**AMENDMENTS TO THE DRAWINGS**

### **REMARKS**

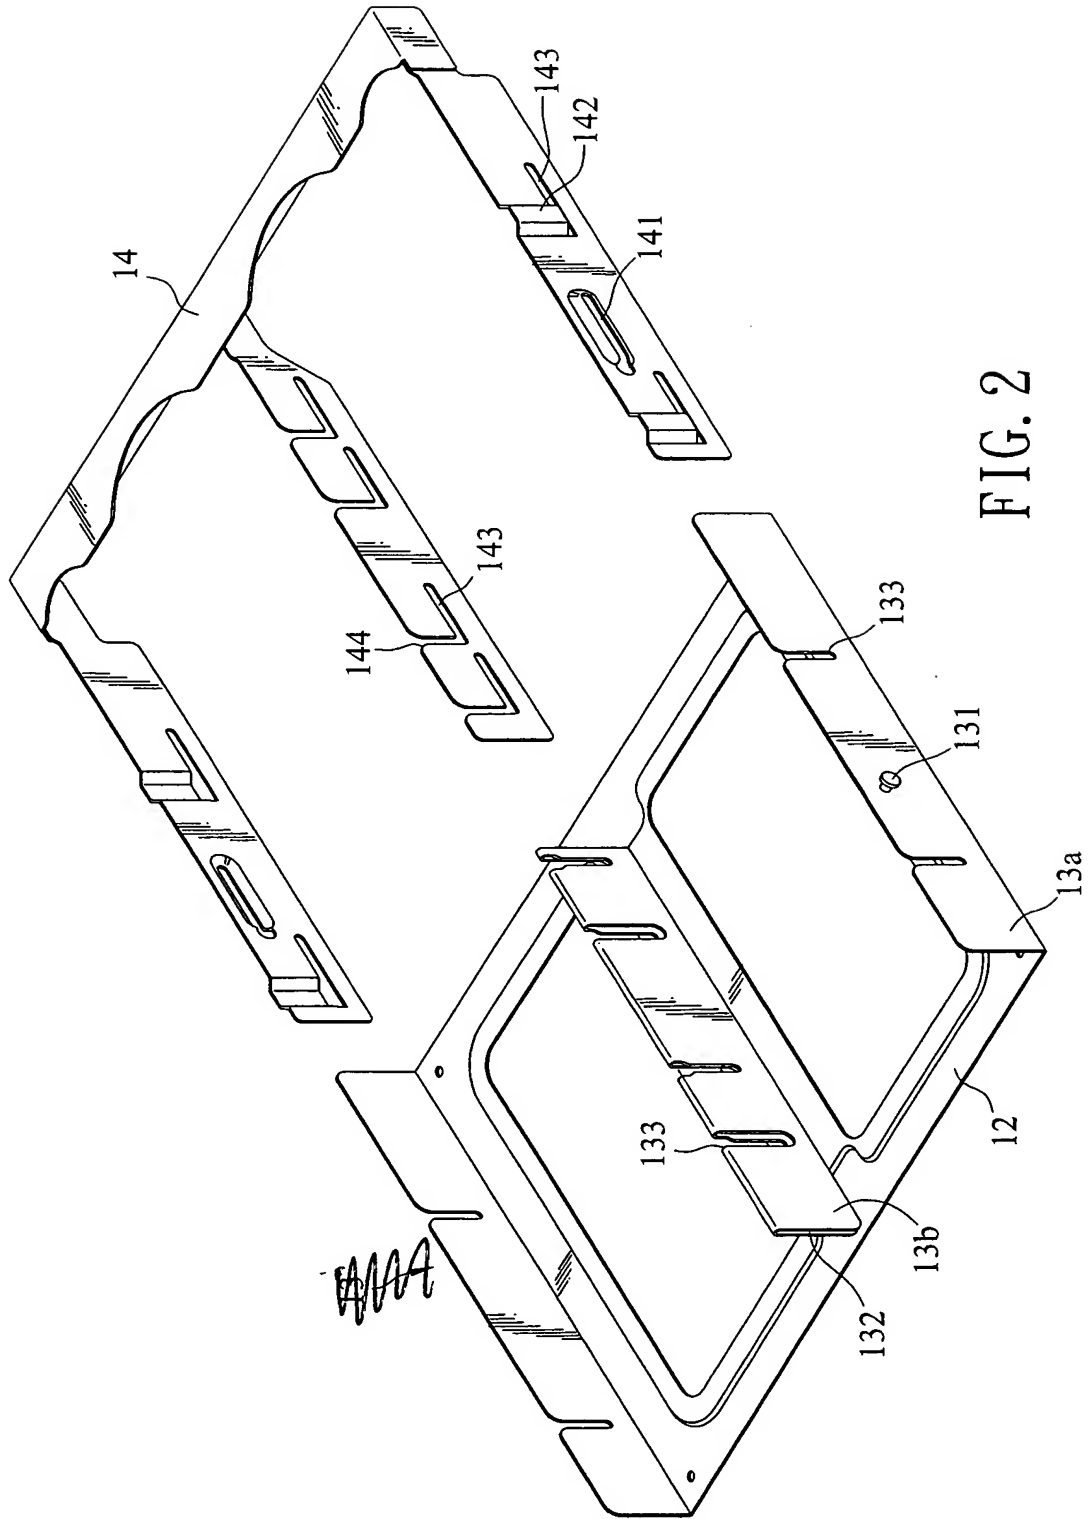
Fig. 2 has been amended to remove reference numeral 13 and its associated lead line; and

The Examiner objected to the drawings as failing to comply with the rules because they include reference numeral 13 which is not included in the specification. By way of the present amendment, Fig. 2 has been corrected to remove reference numeral 13. The Examiner also objected to the drawings as having reference numeral 141 in Fig. 6A, which refers to a different portion than that found in the other figures. By way of the present amendment, Applicants are submitting replacement Fig. 6A, which removes the incorrect reference numeral 141. As required by the Examiner, a marked-up version of the drawings, showing the changes made, is also provided.

FIG. 6A

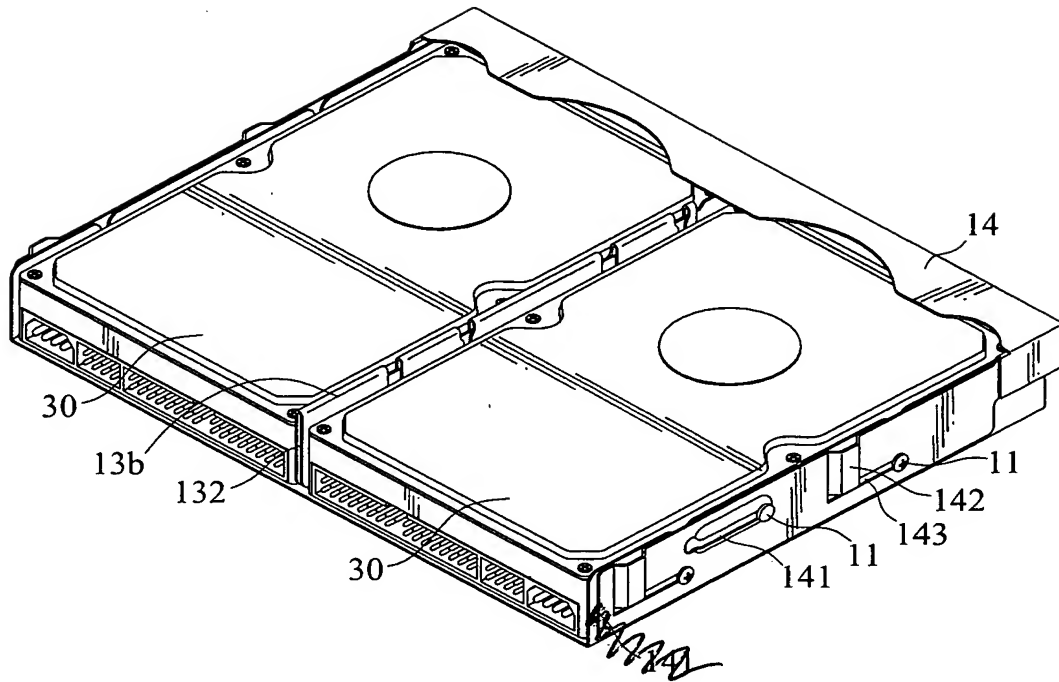
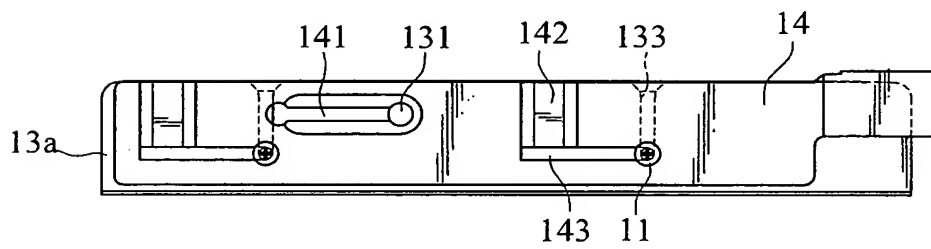
Fig. 6 has been amended to remove one occurrence of reference numeral 141 and its associated lead line.
